UNITED STATES
NUCLEAR REGULATORY COMMISSION
WASHINGTON, D. C. 20555

LICENSEE: Pacific Gas and Electric Company
FACILITY: Diablo Canyon Nuclear Power Plant, Unit 1 and Unit 2
SUBJECT: MEETING SUMMARY - NATURAL CIRCULATION/BORON MIXING/
COOL DOWN TESTS

REVIEW OF
NATURAL CIRCULATION, BORON MIXING AND
COOLDOWN TEST AT DIABLO CANYON

Figure 3.2 RCS flow.

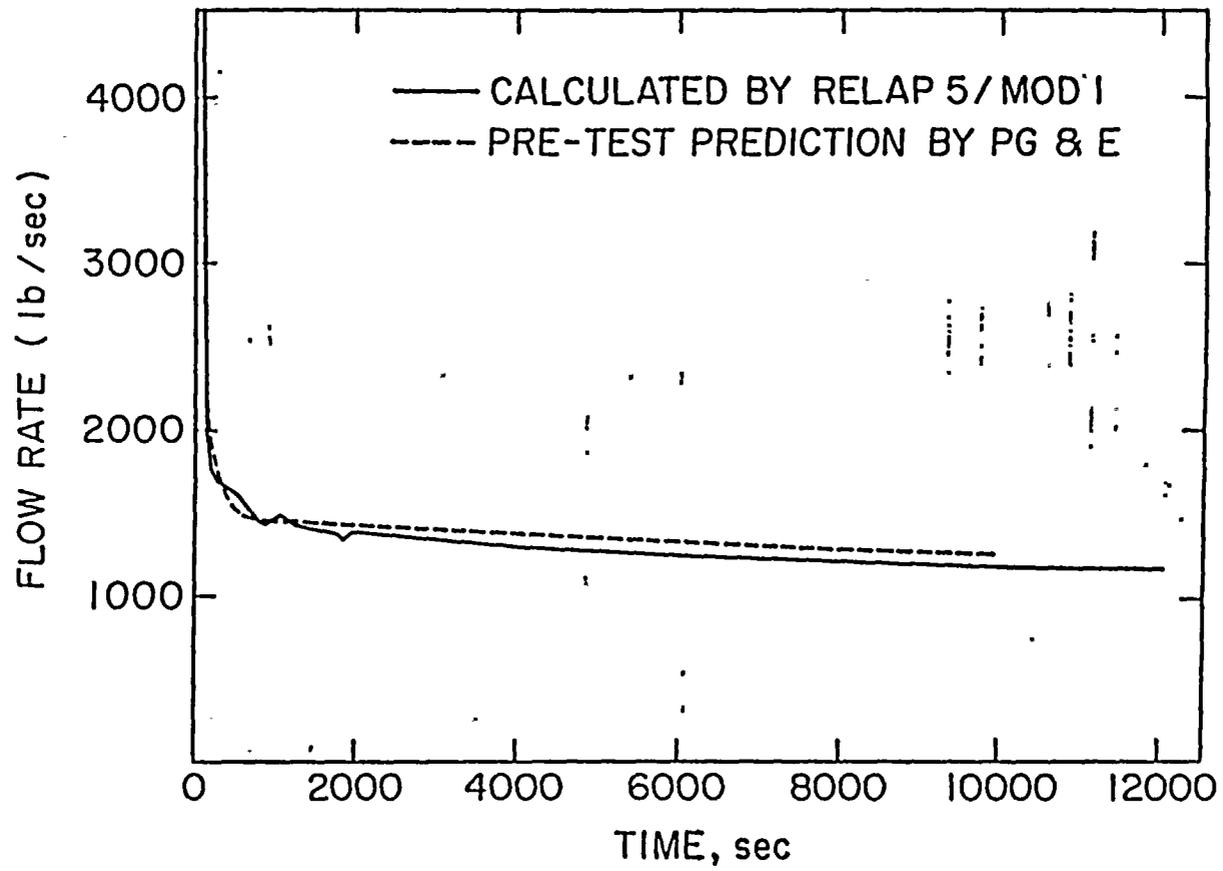
- 1) THE TEST DEMONSTRATED THAT ADEQUATE NATURAL CIRCULATION WAS ESTABLISHED AND THE PLANT WAS CAPABLE OF REMOVING THE DECAY HEAT BY THE NATURAL CIRCULATION USING ONLY SAFETY-GRADE EQUIPMENT.

Figure 3.9 Boron concentration.

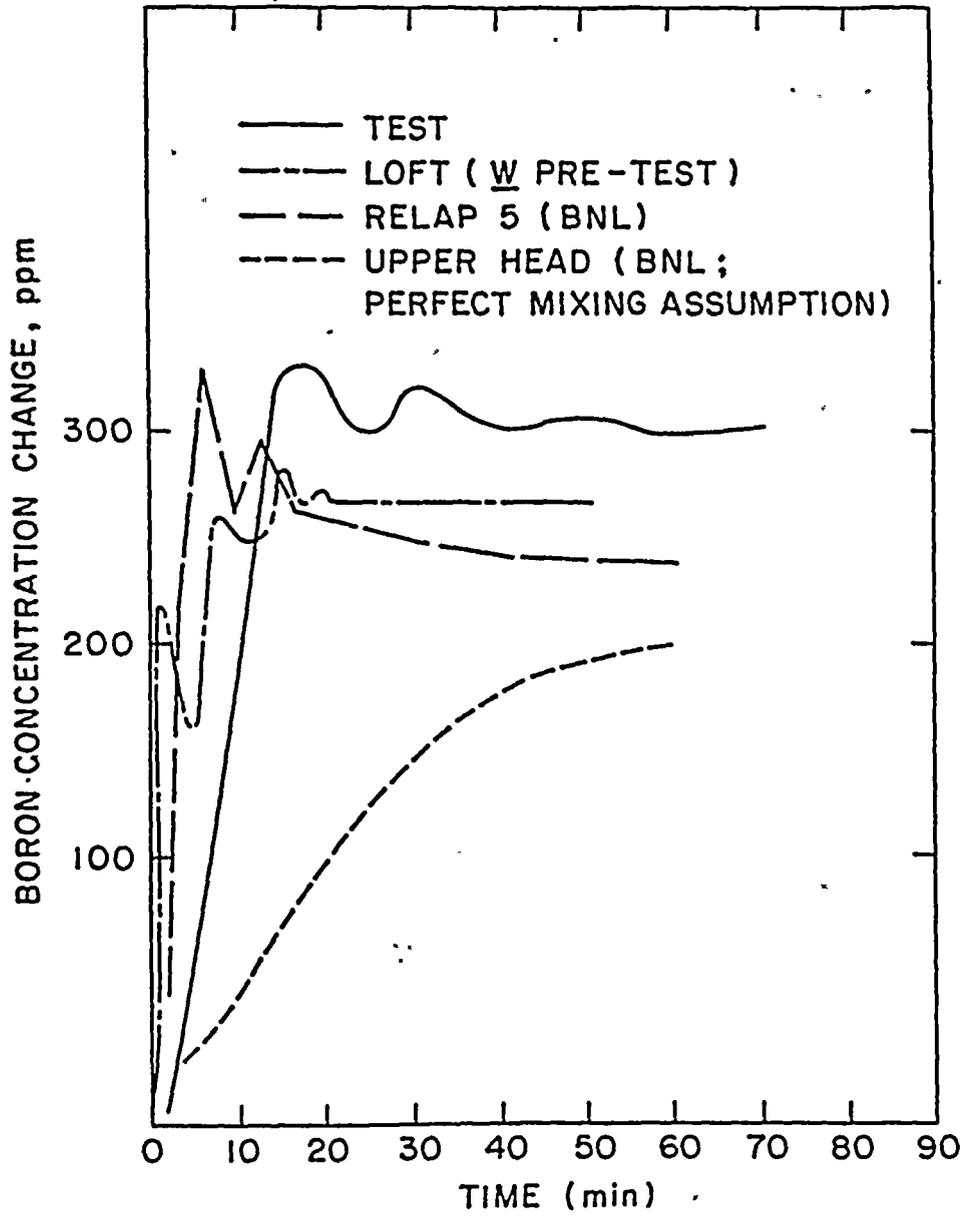
- 2) ADEQUATE BORON MIXING COULD BE ACHIEVED BY THE
NATURAL CIRCULATION IN THE MAIN FLOW PATH OF THE
RCS USING ONLY SAFETY-GRADE EQUIPMENT.

Figure 3.5 RCS pressure and pressurizer level (20°F/hr cooldown).

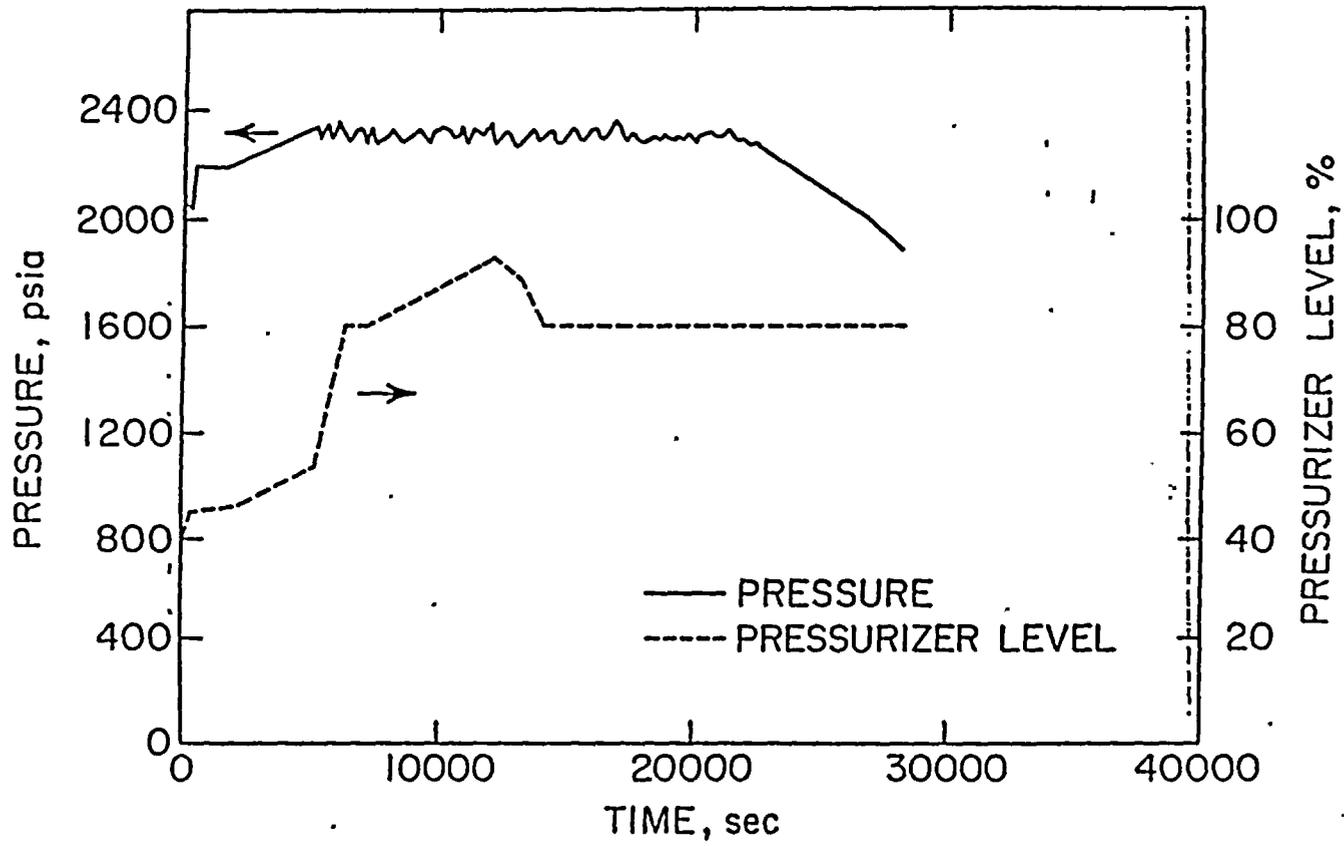
- 4) THE PRESSURE WOULD RISE AND REACH THE PORV ACTUATION PRESSURE WITHOUT LETDOWN DURING THE BORON MIXING PERIOD.

Figure 3.11 Hot leg and saturation temperature of test and calculation (20°F/hr cooldown).

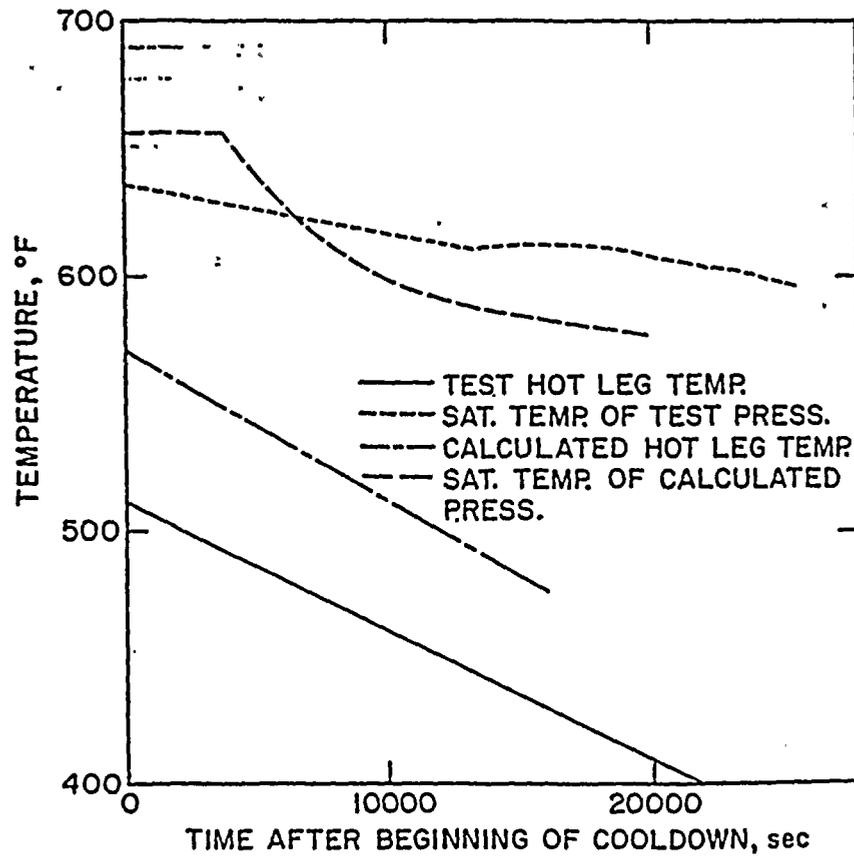
5) THE TEST DEMONSTRATED THAT IT COULD COOL THE MAIN
RCS TO THE RHR SYSTEM INITIATION TEMPERATURE WHILE
MAINTAINING ADEQUATE SUBCOOLING DURING THE NATURAL
CIRCULATION USING ONLY SAFETY-GRADE EQUIPMENT.

Figure 3.12 RCS temperature and saturation temperature with 50°F/hr cooldown.

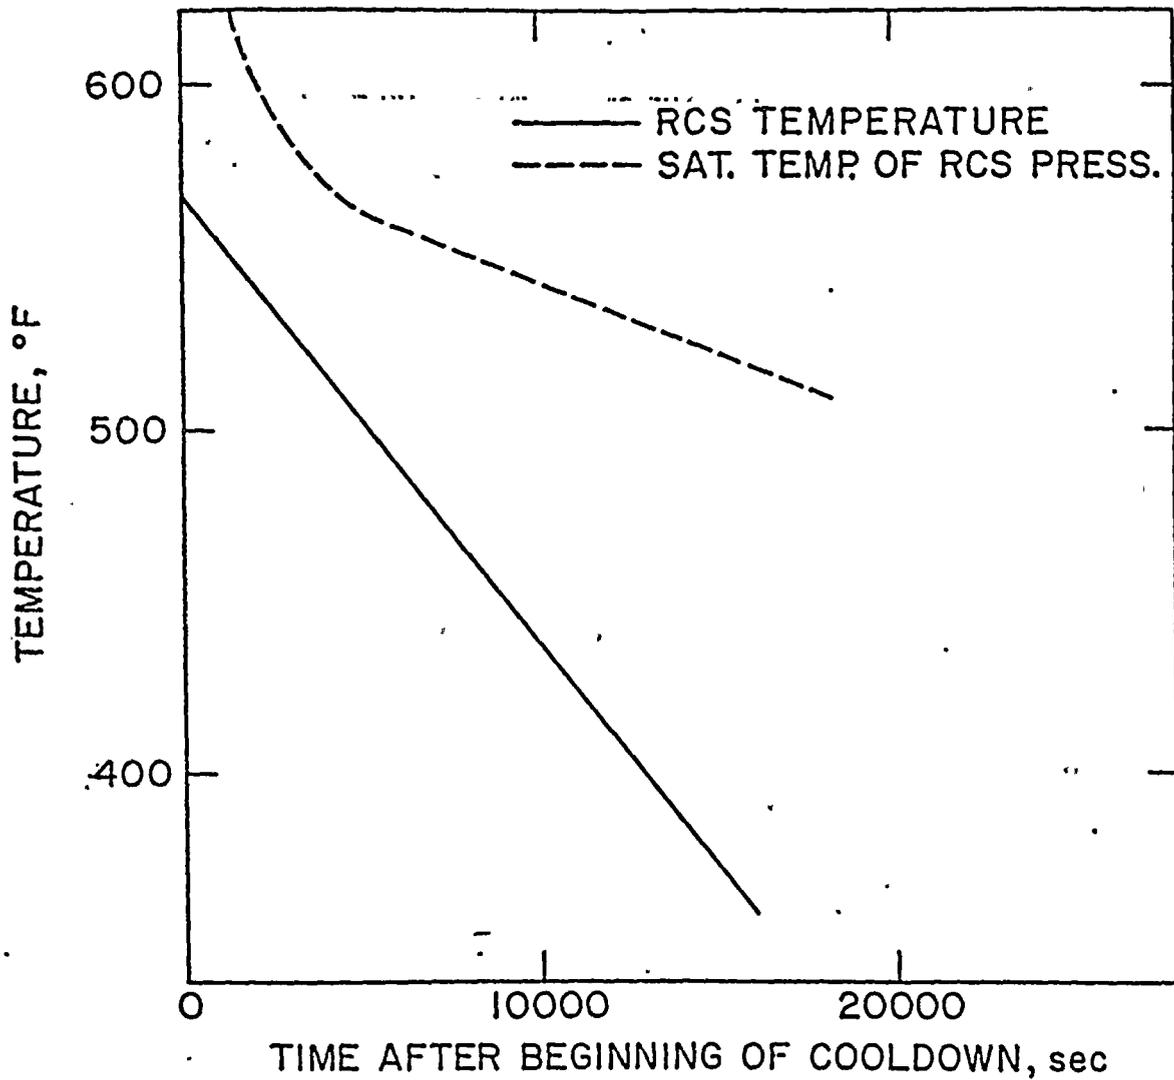
- 11) SUFFICIENT ASD VALVE CAPACITY WAS AVAILABLE TO SUPPORT THE COOLDOWN EVEN WHEN THE COOLDOWN RATE WAS 50°F/HOUR.

Figure 4.1 Margin of subcooling in the upper head with CRDM fans in operation.

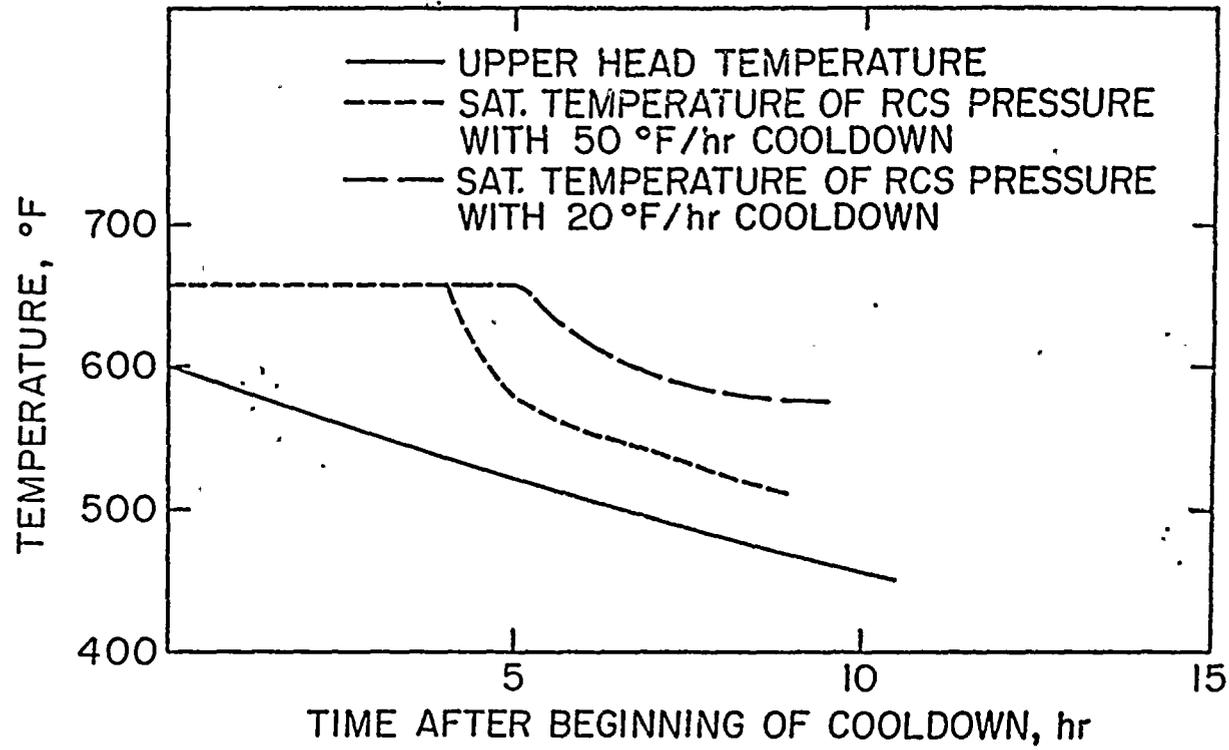
- 6) THE TEST DEMONSTRATED THAT THE UPPER HEAD COULD BE COOLED WITHOUT VOID FORMATION WHEN THE CRDM FANS WERE IN OPERATION.

Figure 4.2 Upper head temperature when loss is due to conduction only (25°F/hr cooldown of RCS).

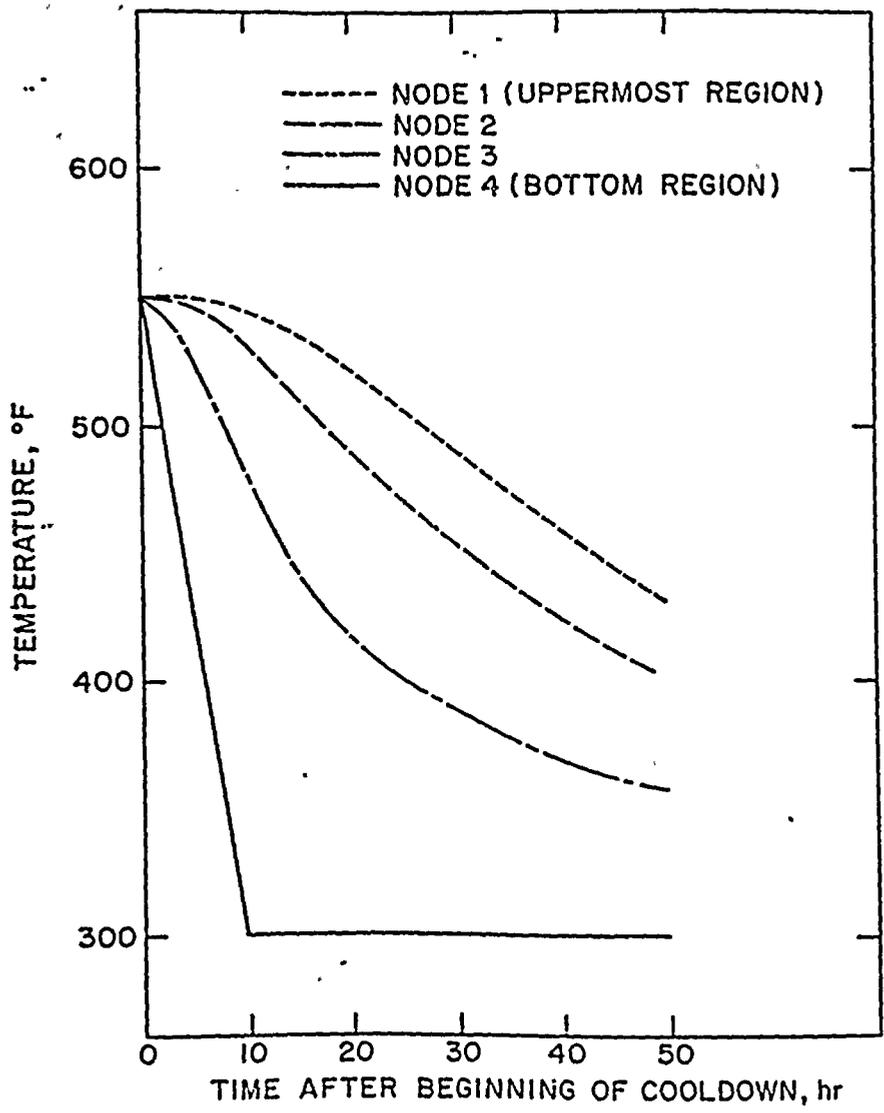
- 7) THE TEST RESULTS INDICATE THAT THE UPPER HEAD COOLDOWN RATE WITHOUT THE CRDM FANS IS ABOUT 6°F PER HOUR. THIS IS HIGHER THAN THE CONSERVATIVE BNL CALCULATION (ACCOUNTING ONLY FOR CONDUCTION HEAT LOSS) WHICH ESTIMATED A MINIMUM RATE OF 3°F/HOUR.

Figure 4.3 Upper head temperature and saturation temperature of RCS pressure with 20°F/hr cooldown.

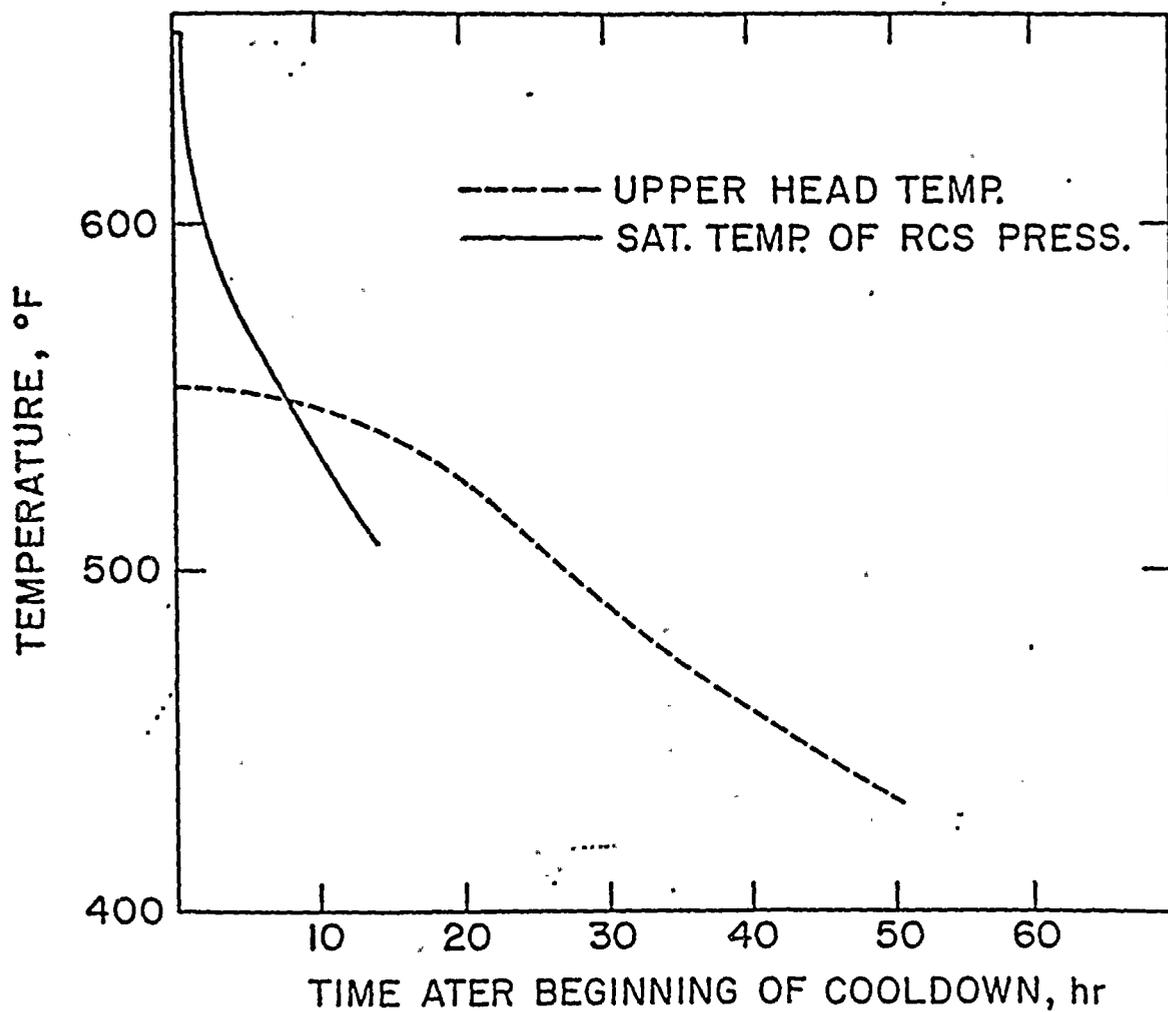
- 8) THE RCS PRESSURE SHOULD BE MAINTAINED ABOVE 1200 PSIA BY MEANS OF EITHER THE PRESSURIZER HEATERS (IF AVAILABLE) OR CHARGING DURING THE COOLDOWN PERIOD TO AVOID THE VOID FORMATION IN THE UPPER HEAD WHEN THE CRDM FANS WERE NOT IN OPERATION.

Figure 3.15 Accumulated cooling water.

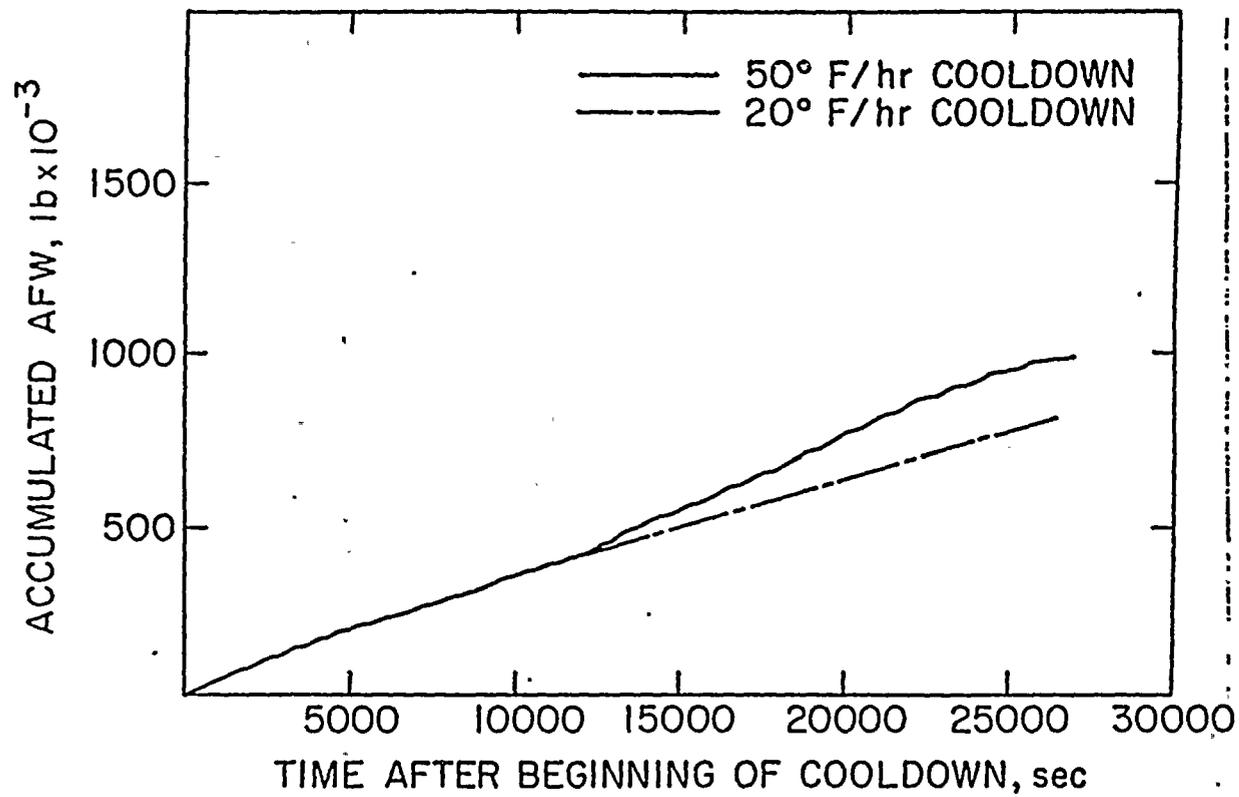
- 9) SUFFICIENT SUPPLY OF SAFETY GRADE COOLING WATER WAS AVAILABLE TO SUPPORT THE PROPOSED PLANT COOLDOWN METHOD EVEN IF THE CRDM FANS WERE NOT AVAILABLE FOR THE DIABLE CANYON PLANT BUT THE WORST CASE REQUIREMENTS (360,000 GALLONS) MAY NOT BE AVAILABLE AT ALL PLANTS.
